Title: Arbor Gate Development Comprehensive Sign Package Amendment 2026

Re: Letter of Intent for a proposed amendment to the approved Comprehensive Sign Package at Arbor Gate Project No. 2004-06.10

ARBOR GATE SIGN PACKAGE AMENDMENT 2026

North Side of West Building with Close-up
of Proposed Additional Sign Location on Stone Signage Band

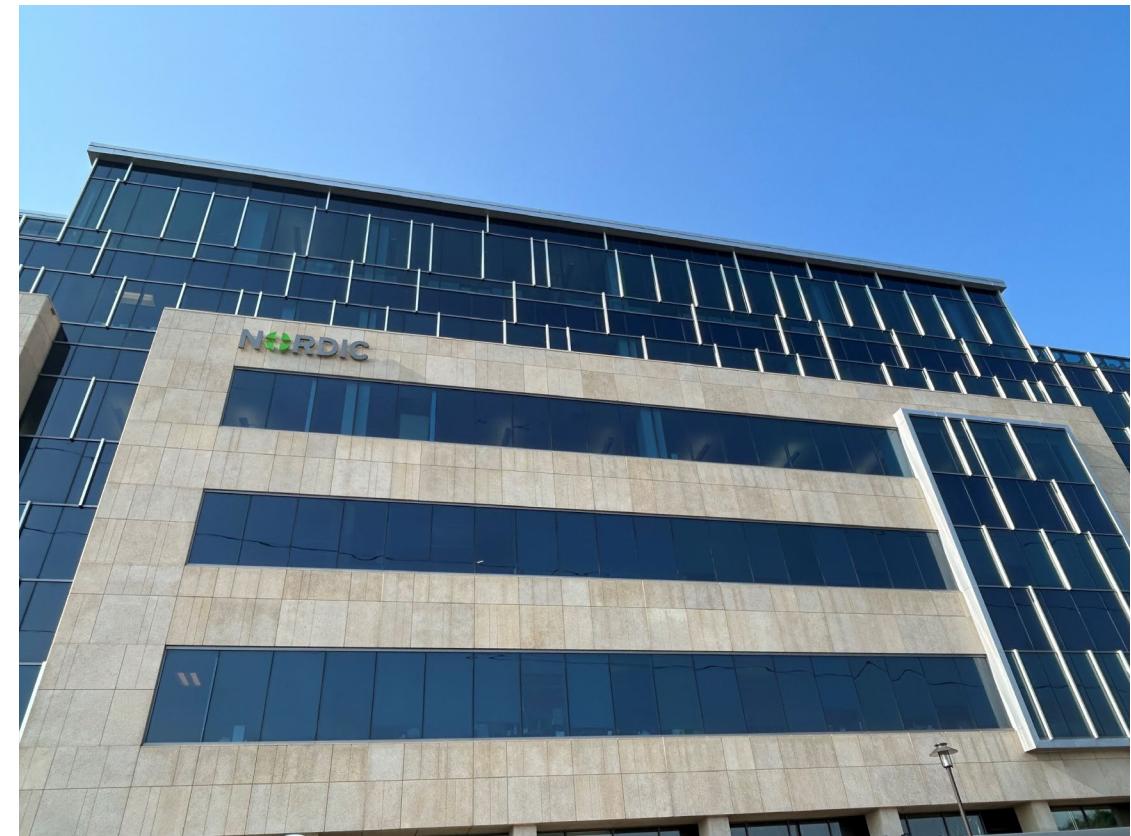
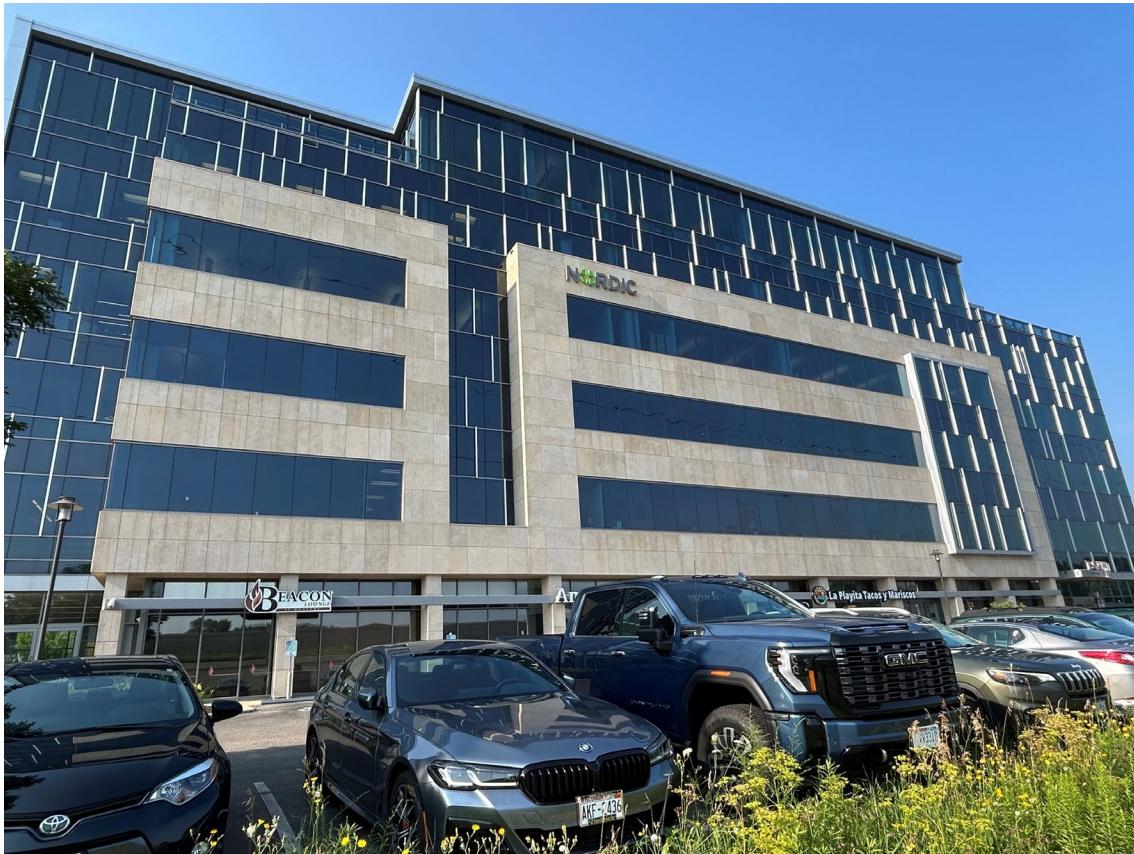
- Proposed Signage will match all specifications and requirements per existing sign package

- The permitted maximum number of secondary tenant signs in the stone signage band of the East Tower is **four: three** on the north and one on the east, as shown.

- The permitted maximum number of secondary tenant signs in the stone signage band of the West Tower is **four: three** on the north and one on the west, as shown.
